SERVICE BULLETIN

TITLE: FUSELAGE - WING FORWARD SPAR CARRY-THRU STRUCTURE INSPECTION AND/OR REINFORCEMENT

Issued: August, 1989
Revised: June, 2004

SB 53-2269, REV. 2

Figure 1

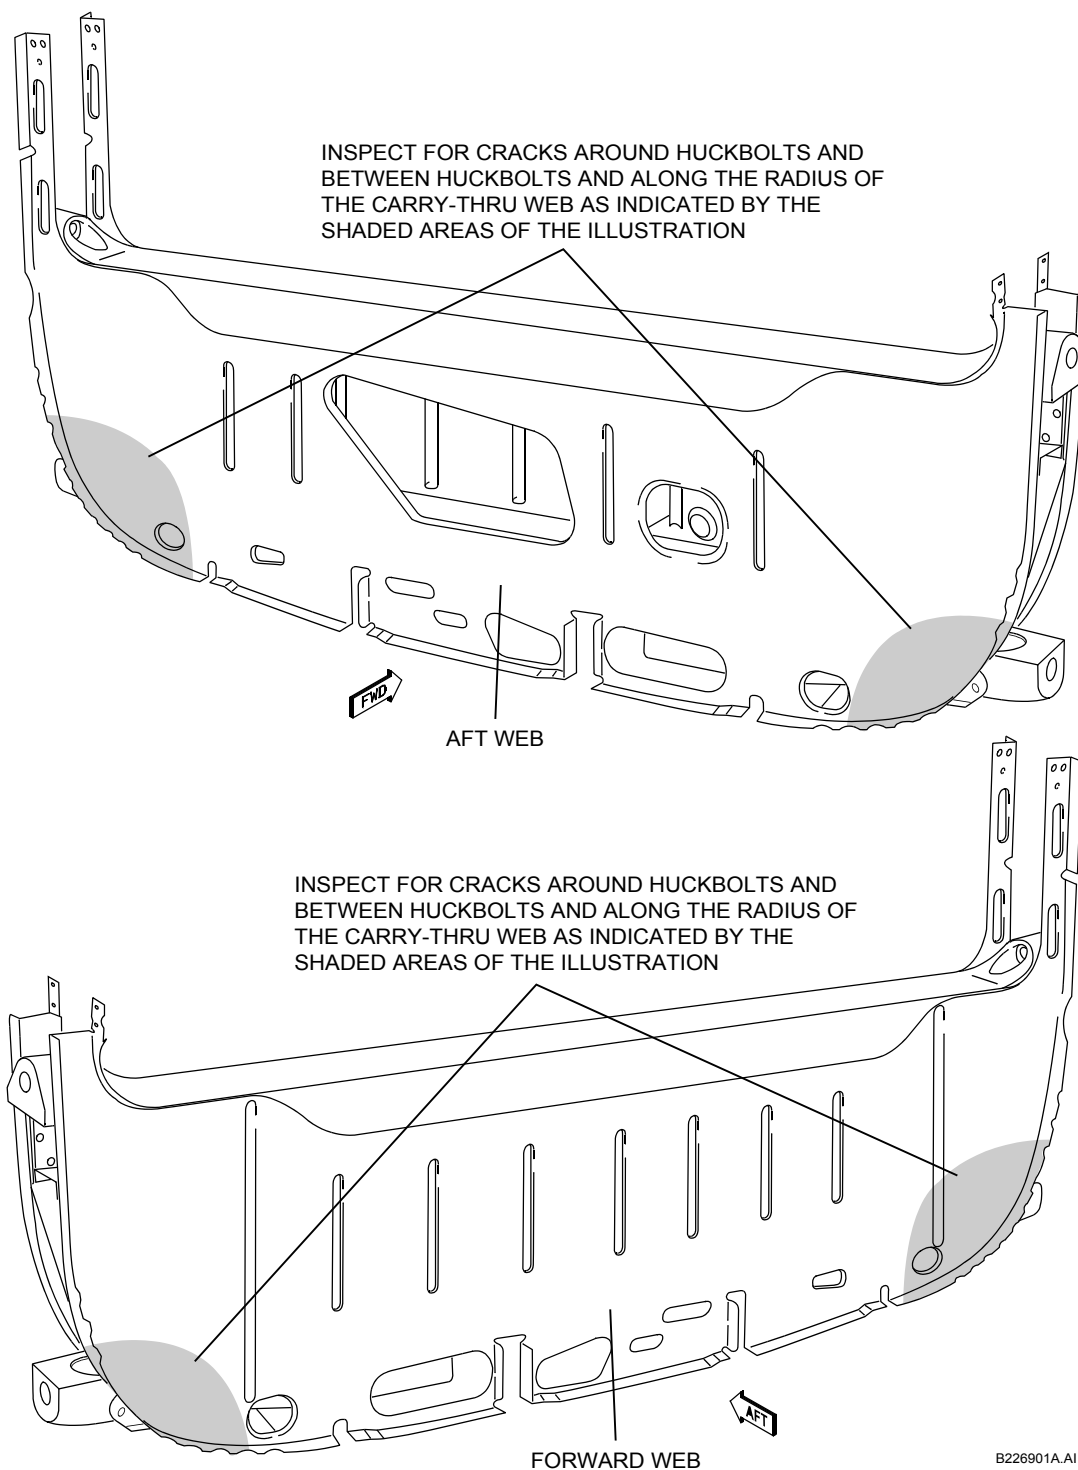
- (2) Remove the pilot's and copilot's seats and the carry-thru cover to obtain access to the front spar carry-thru structure.
- (3) Thoroughly clean the forward and aft frames (webs) of the front spar carry-thru structure in the shaded areas shown in Figure 1.
- (4) Perform a visual inspection of the area cleaned in step 3 for evidence of cracks.
- (5) Perform a dye penetrant inspection using visible dyes, of the area cleaned in step 3 for evidence of cracks.

Any of the shaded areas shown in Figure 1 that are modified by the installation of a doubler need not be dye-penetrant inspected until 1500 flight hours after the installation of that particular doubler. If no cracks are found, repeat the inspection every 500 flight hours.

Cracks found in the shaded areas of Figure 1 that have not been modified by a doubler must be repaired as indicated in this Service Bulletin on an individual basis.

- (i) A crack up to 4.0 inches in length shall be stop drilled at the ends using a #30 drill bit. The area is to be repaired per the applicable P/N 58-4008 Kit(s) within the next 100 flight hours, 12 calendar months or the next scheduled inspection whichever occurs first.

- (ii) A crack exceeding 4.0 inches in length shall be repaired PRIOR TO FURTHER FLIGHT per the applicable P/N 58-4008 Kit(s).

- (i) A crack emanating from one fastener in two directions is considered to be one crack. **Do not stop drill, due to the possibility of damaging structure behind web face.**
- (ii) Any crack shall be repaired per the applicable P/N 58-4008 Kit(s), within the next 25 flight hours, 12 calendar months or the next scheduled inspection whichever occurs first.
- (iii) A crack passing through two fasteners and extending beyond for more than 0.5 inch on either end shall be repaired PRIOR TO FURTHER FLIGHT, per the applicable P/N 58-4008 Kit(s).
- (iv) A crack passing through two fasteners and extending beyond for less than 0.5 inch on both ends shall be repaired per the applicable P/N 58-4008 Kit(s), within the next 25 flight hours, 12 calendar months or the next scheduled inspection whichever occurs first.

(c) If cracks are found in both the forward and aft frames on the same side of the airplane, in either the web face and/or the bend radius, and any of the cracks are more than 1.0 inch long, a repair shall be made PRIOR TO FURTHER FLIGHT.

(d) If cracks are found in both the forward and aft frames on the same side of the airplane, in either the web face and/or the bend radius, and all of the cracks are less than 1.0 inch long, a repair shall be made per the applicable P/N 58-4008 Kit(s) within the next 25 flight hours, 12 calendar months or the next scheduled inspection whichever occurs first.
